W50P19-0001
Wayne Ford
Submission

**SPECIAL USE PERMIT REQUEST; WSUP19-0001 INCLINE VILLAGE MONOPOLE
THERE SHOULD BE ONE OUTCOME FOR THIS APPLICATION ; DENIED**

SCENIC EVALUATION

SITE PLAN ALL SITE FEATURES

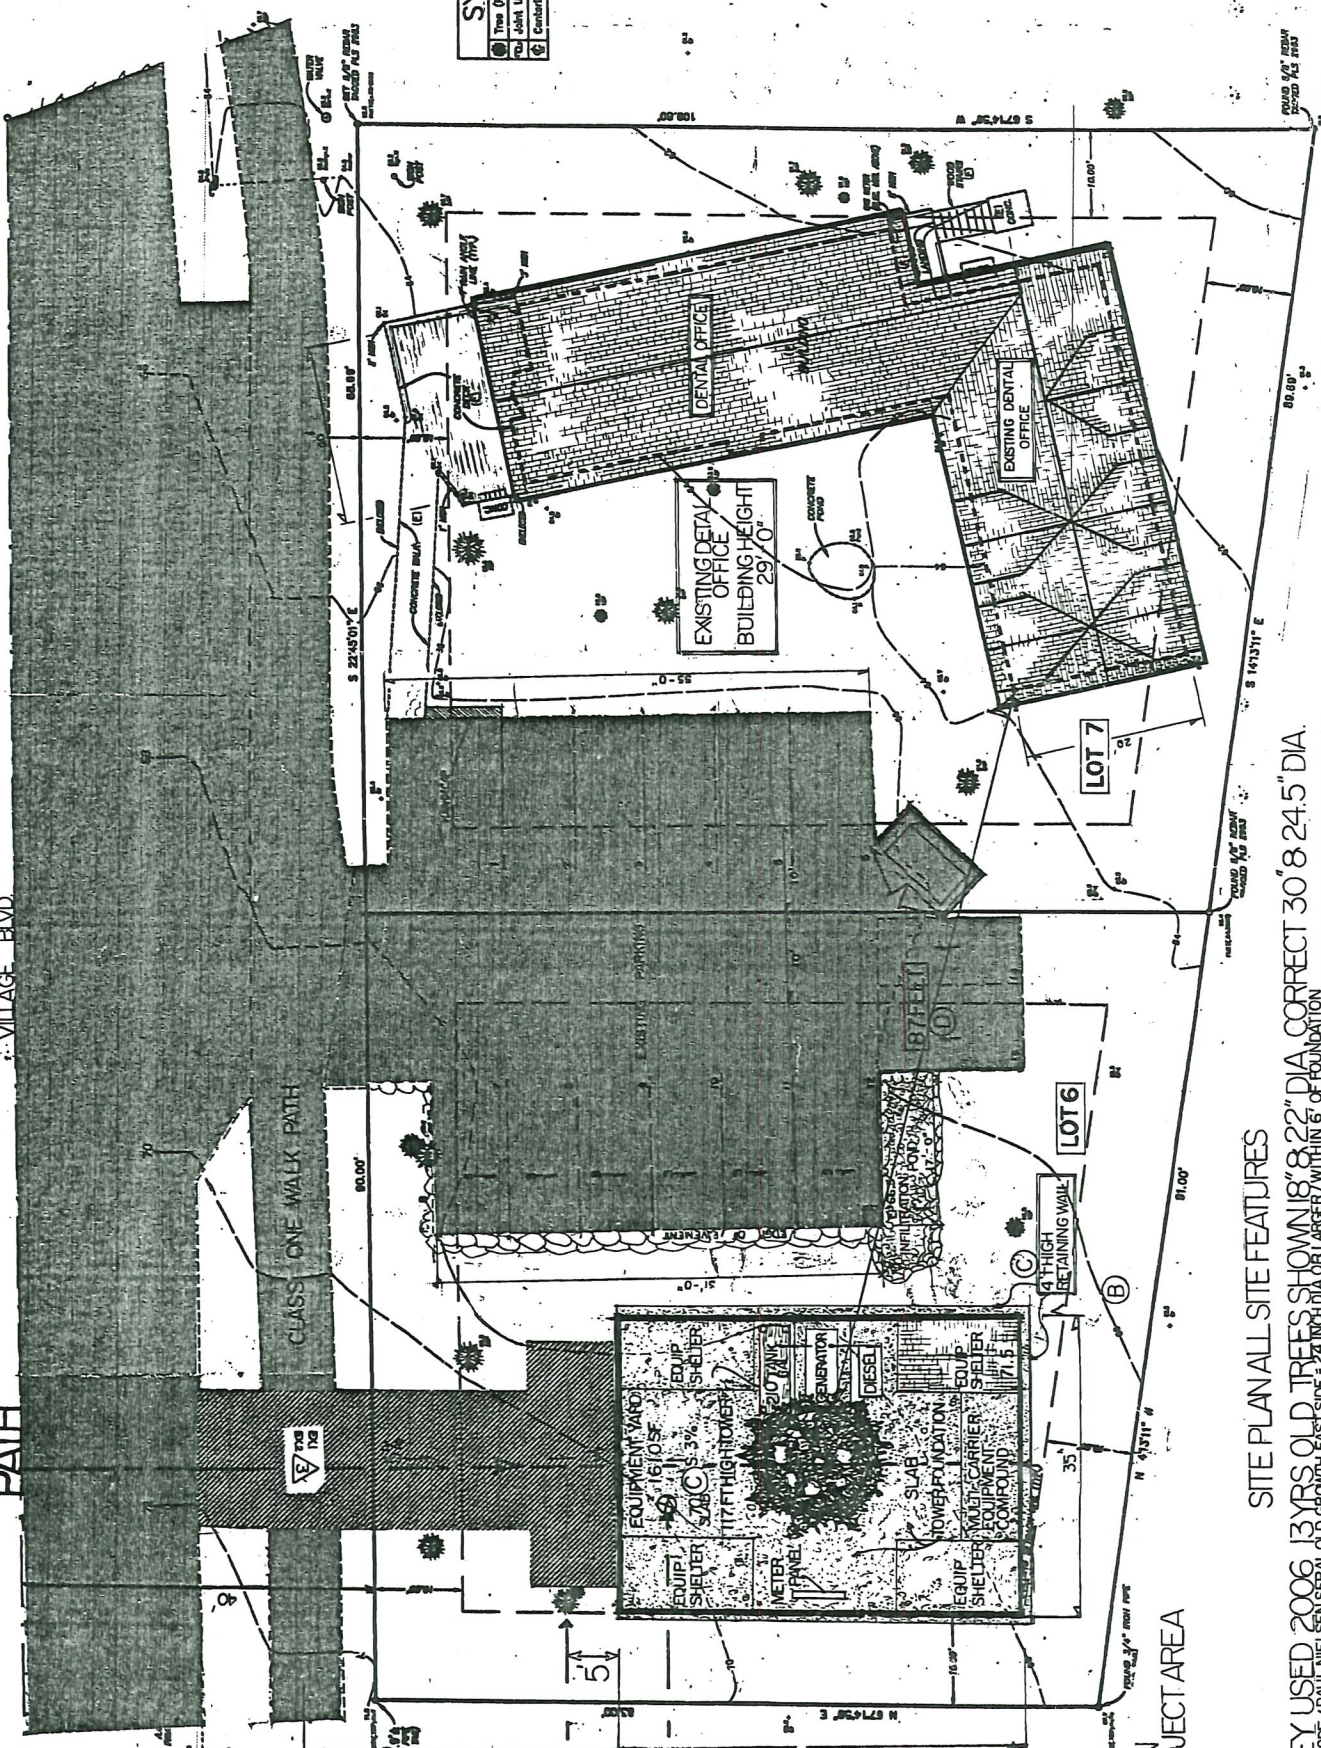
- A: SURVEY USED 2006 13 YRS OLD TREES SHOWN 18" 8.22" DIA CORRECT 30' 8" 24.5" DIA. JULY 2001 CODE / PAUL NIELSEN SERIAL OLD GROWTH EAST SIDE = 24" INCH DIA OR LARGER AND 12' OF FOUNDATION TREES TO BE RETAINED UNLESS ALL REASONABLE ALTERNATIVES ARE NOT FEASIBLE TO RETAIN THE TREE. INCLUDING MODIFICATIONS OF ORIGINAL DESIGN.
- B: DENTAL OFFICE ON TRPA APPLICATION, NOT SHOWN FOR COUNTY DRAWINGS / 87' FROM TOWER
- C: NO GRADES SHOWN
- D: EQUIPMENT YARD SLAB ELEVATION NOT SHOWN USE TO TRPA SLAB 3% CODE
- E: TOWER TO BE 17' Z DENTAL OFFICE 29'-0"

FIRST: THE SITE PLAN SUBMITTED TO THE COUNTY LEFT OFF THE FOLLOWING;

**THE DENTAL BUILDING WHICH IS PART OF THE PROJECT AREA WITH IT'S
PARKING ON THE LOT . THE DENTAL OFFICE IS 87 FEET FROM THE TOWER.
THE BUILDING IS ONLY 39 FEET TALL. THE PROPOSED TOWER WILL BE SOME 117
FEET. NEXT TO THE DENTAL BUILDING**

**THE EQUIPMENT YARD IS 87 FEET AWAY. THE APPLICANT LEFT OFF ALL GRADES
FOR THE SITE. SO THE REAR OF THE YARD, BEING LEVEL WILL BE SOME 4 FEET
TALL AND HAVE A FENCE 6 FEET ABOVE THAT. THAT IS 10 FEET TALL.**

**THE APPLICANT LEFT OFF THE CORRECT TREE SIZES, WHICH UNDER TRPA CODE
ARE 24.5 INCHES IN DIAMETER AND 30 INCHES IN DIAMETER. THEY ARE
PROTECTED TREES, THE 24.5 CAN ONLY BE REMOVED IF A SPECIAL REVIEW
PROCESS IS DONE. THEY MISLED THE TRPA PLANNER. LIKE THEY ARE TRYING TO
MISLEAD THIS BOARD FOR THE CELL COVERAGE AND VISUAL IMPACT.**

VIEW FROM CLASS I PATH

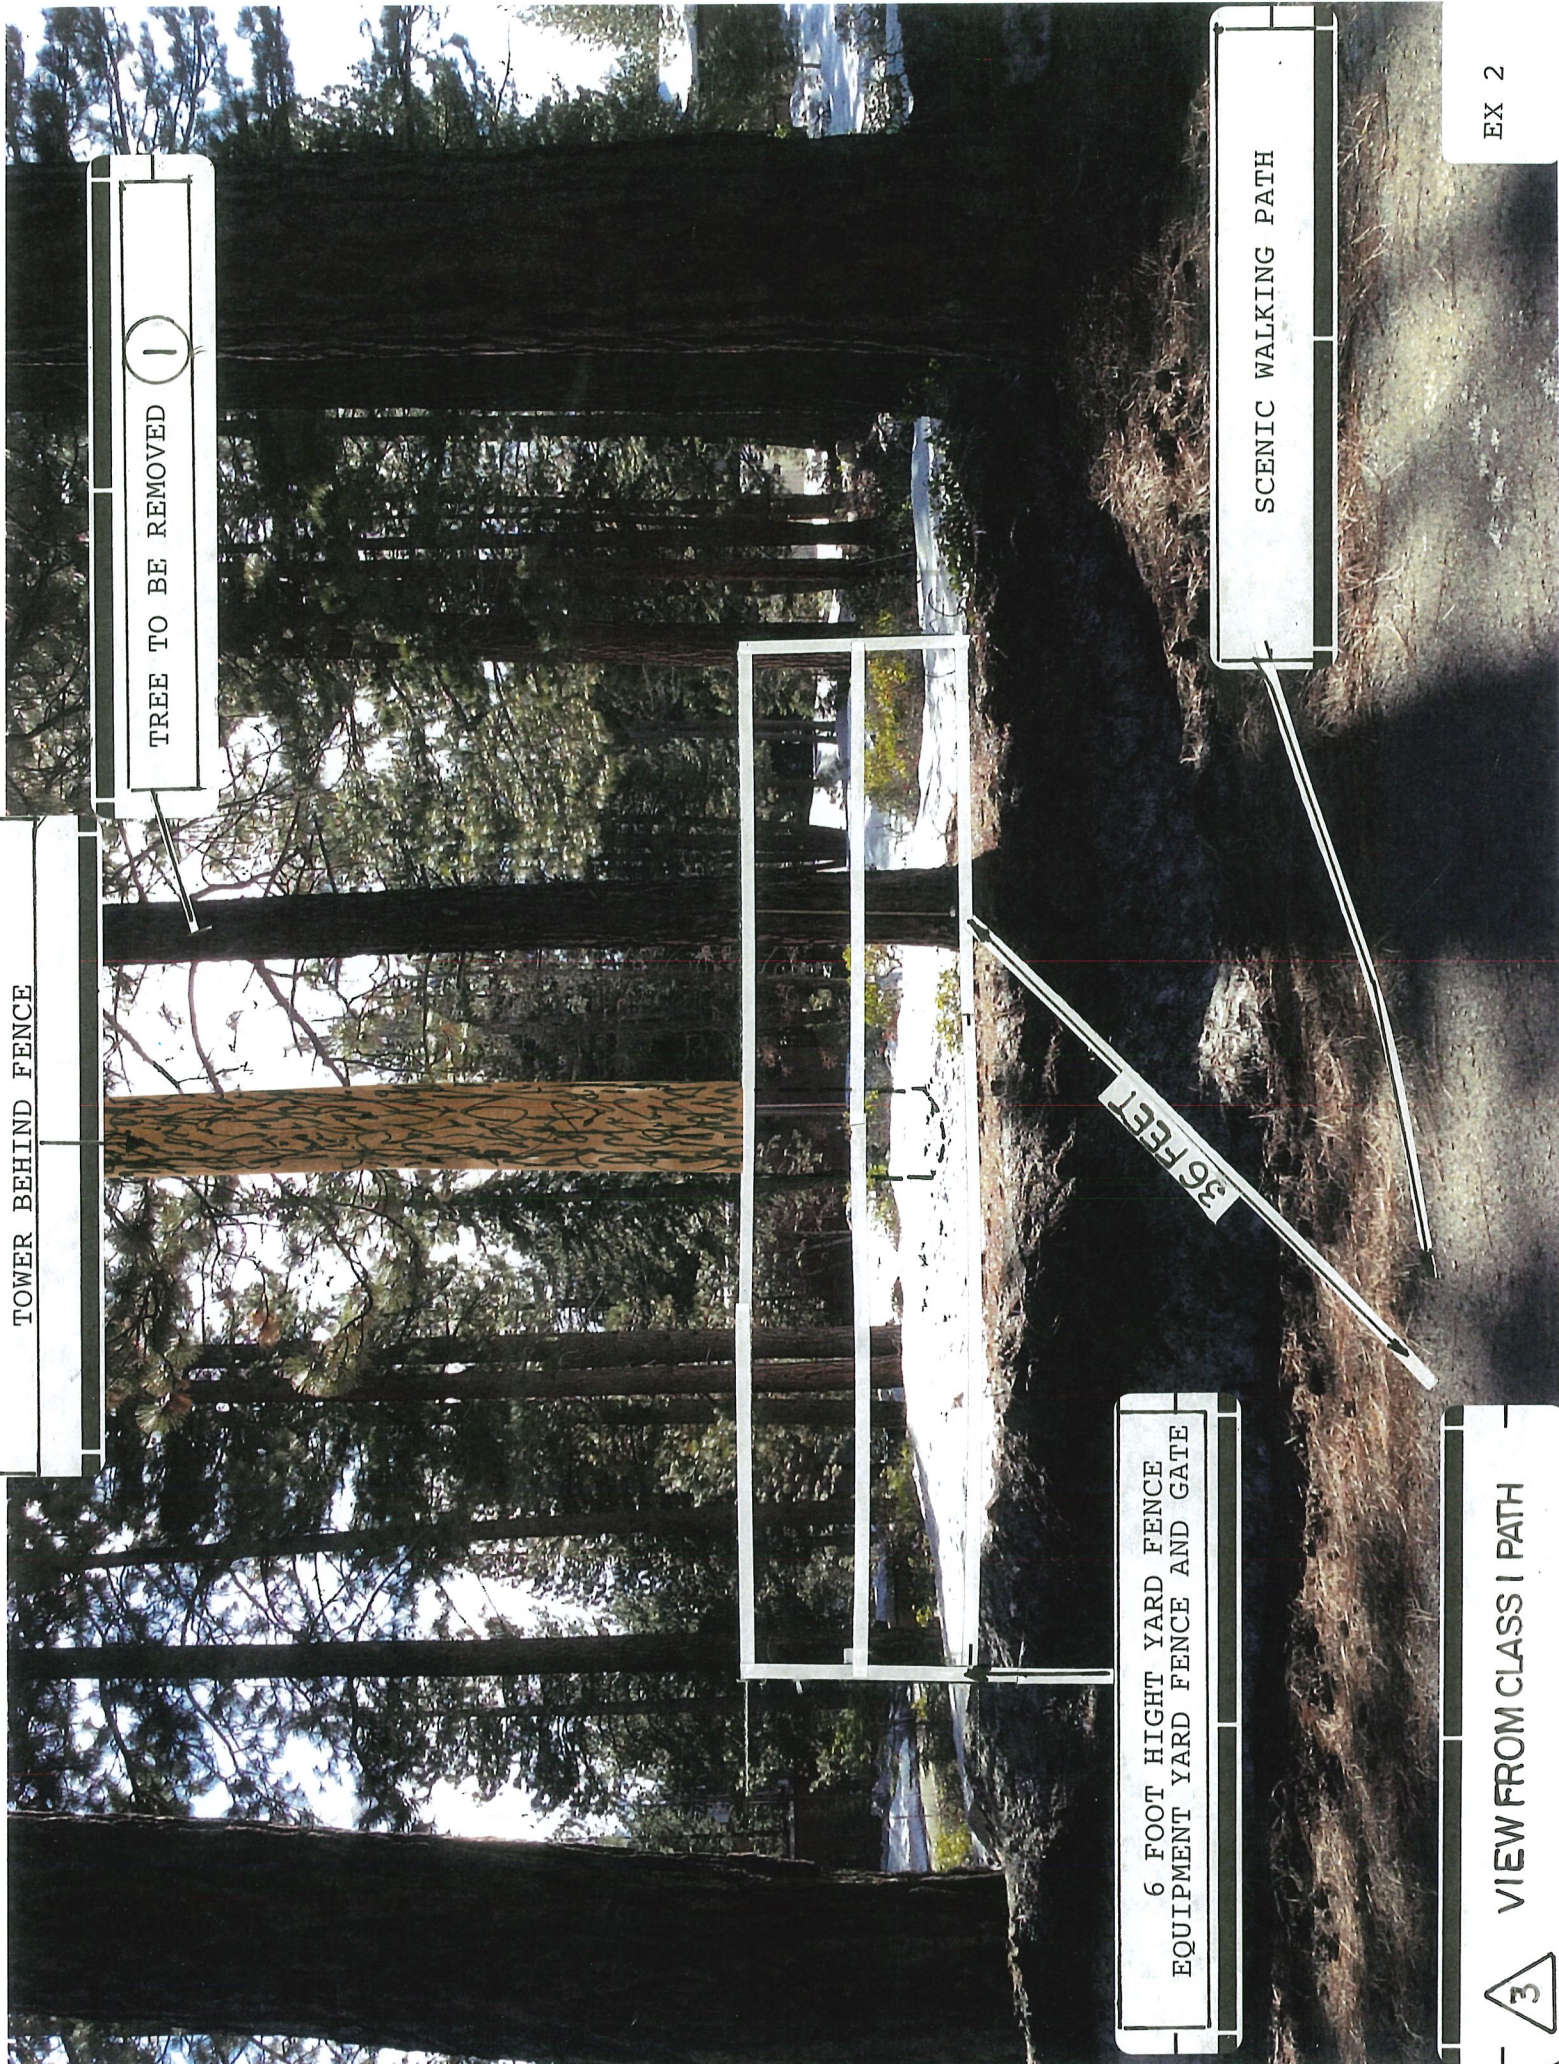
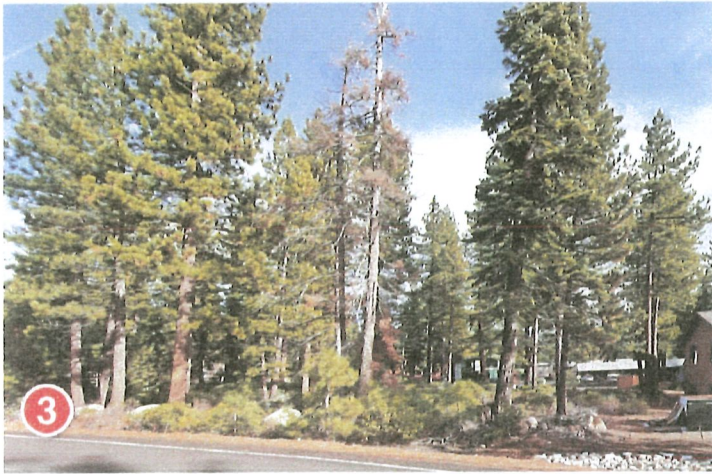
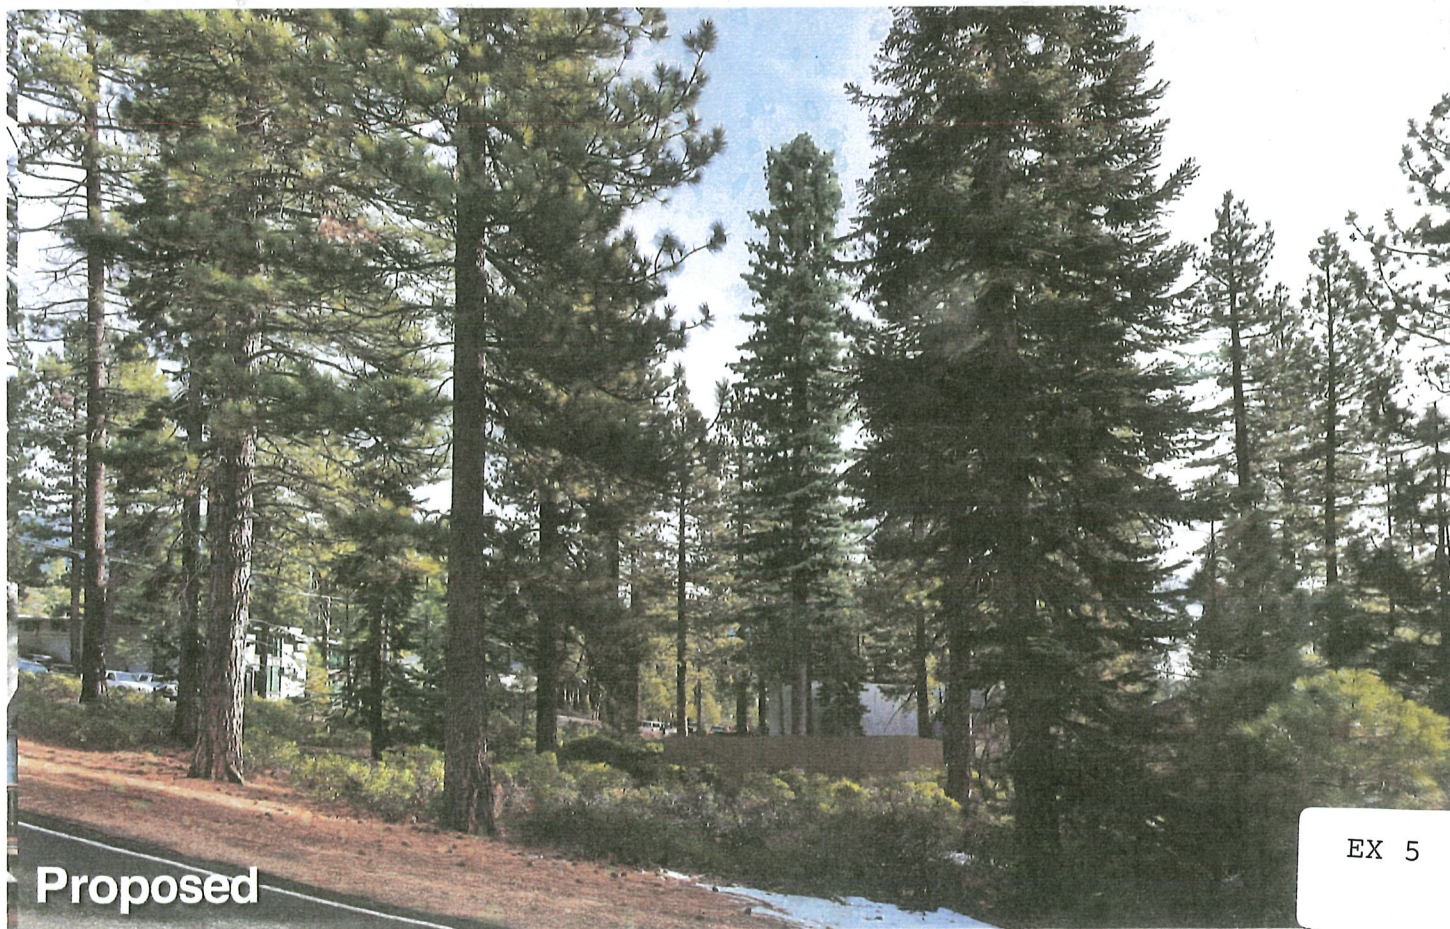
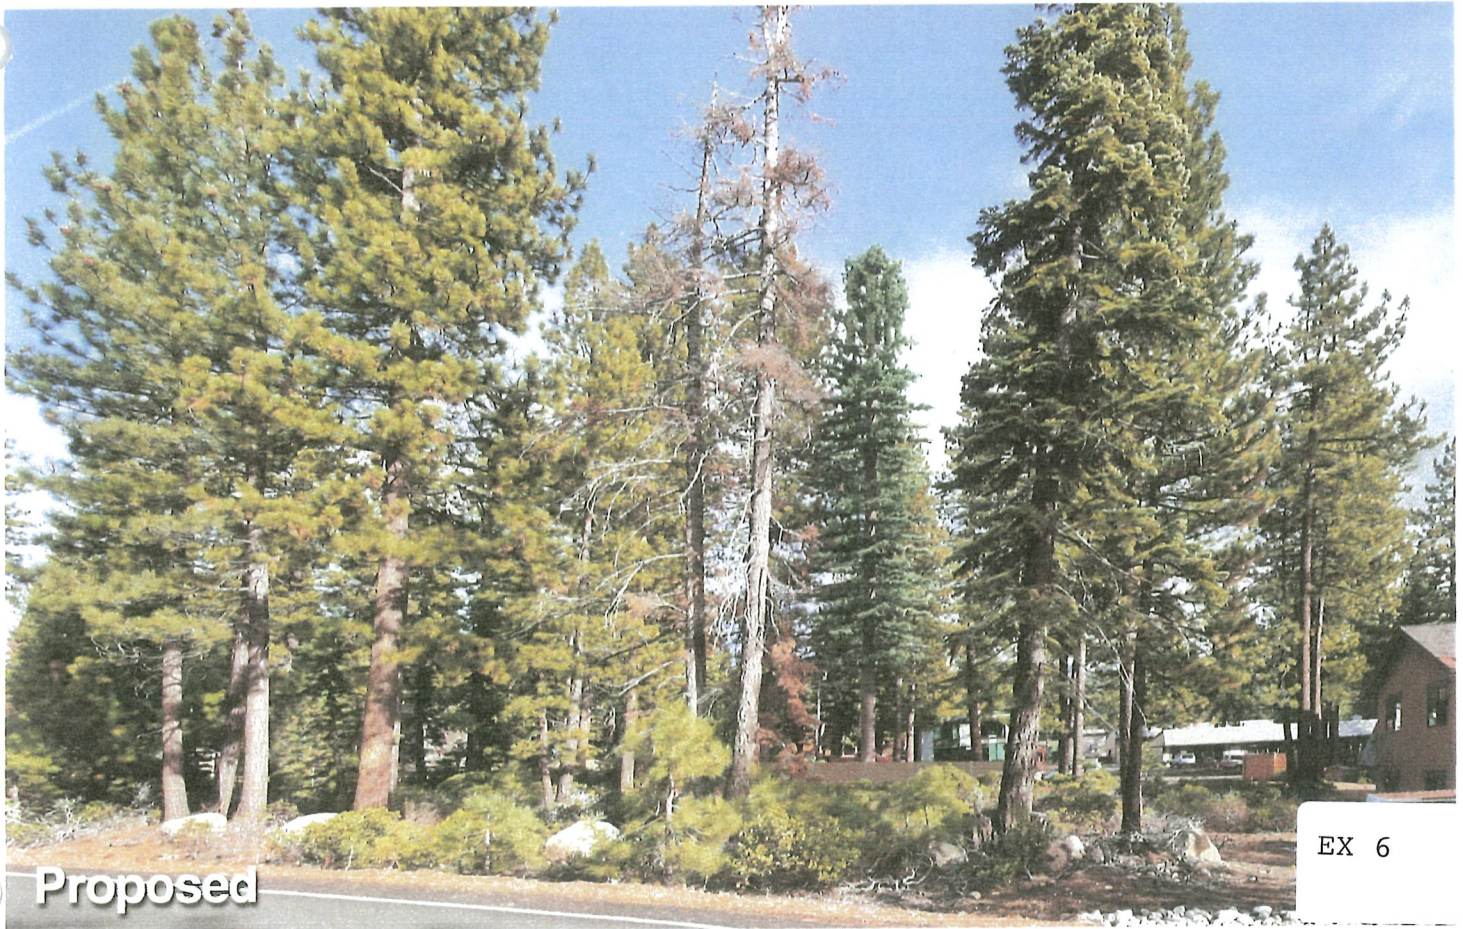
**THAT IS ALSO A FALSE REPRESENTATION ; NOT THAT THE PHOTOS ARE OFF, NO
THEY ARE CORRECT.**

**WHAT IS OFF IS WHERE THEY WERE TAKEN FROM, NOT IN FRONT OF THE
PROPERTY WHERE THERE IS A CLASS 1 WALK PATH WHERE 1000'S OF PEOPLE
WALK EACH DAY. WE WERE THERE ON THE 2, RAIN AND SNOW AND 4 PEOPLE
WALED BY IN A 20 MINUTE TIME PERIOD. JUST WAIT UNTIL SUMMER.**

**THE PICTURE IN THE PACKED SHOWS THE FENCE THAT WILL BE SEEN FROM THE
PATH. NOTE: THE OPEN AND NATURAL SITE , NOW WILL BE FILLED IN WITH A
YARD WITH A GENERATOR, GAS TANK, EQUIPMENT AND SHELTERS, RIGHT IN THE
MIDDLE OF THE MAIN TOURIST, COMMERCIAL AREA OF INCLINE.**
